City of Bixby Planning Commission Meeting Agenda

Monday, March 18, 2024

RE: **SITE PLAN | (BXSP 24.04) Bixby Dental Offices**

RE: **COMPREHENSIVE PLAN AMENDMENT** |
(BXCP-24.01) A major amendment is being
requested to change from Low-Density Residential to
Medium-Density Residential.

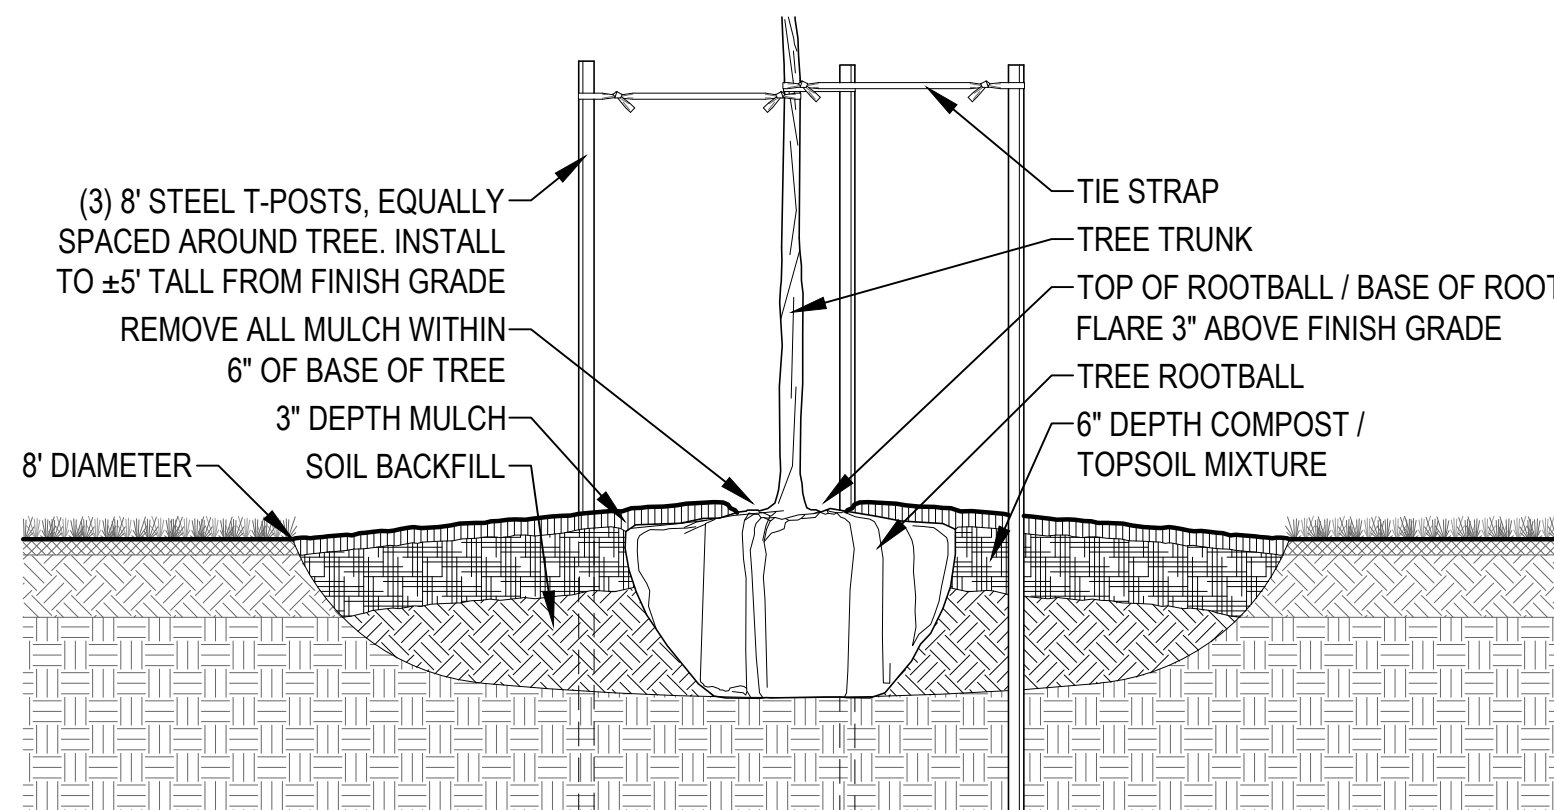
The proposed Site Plan is in conformance to the existing zoning and PUD. Staff recommends relocating the proposed trees away from the existing Sanitary Sewer main.
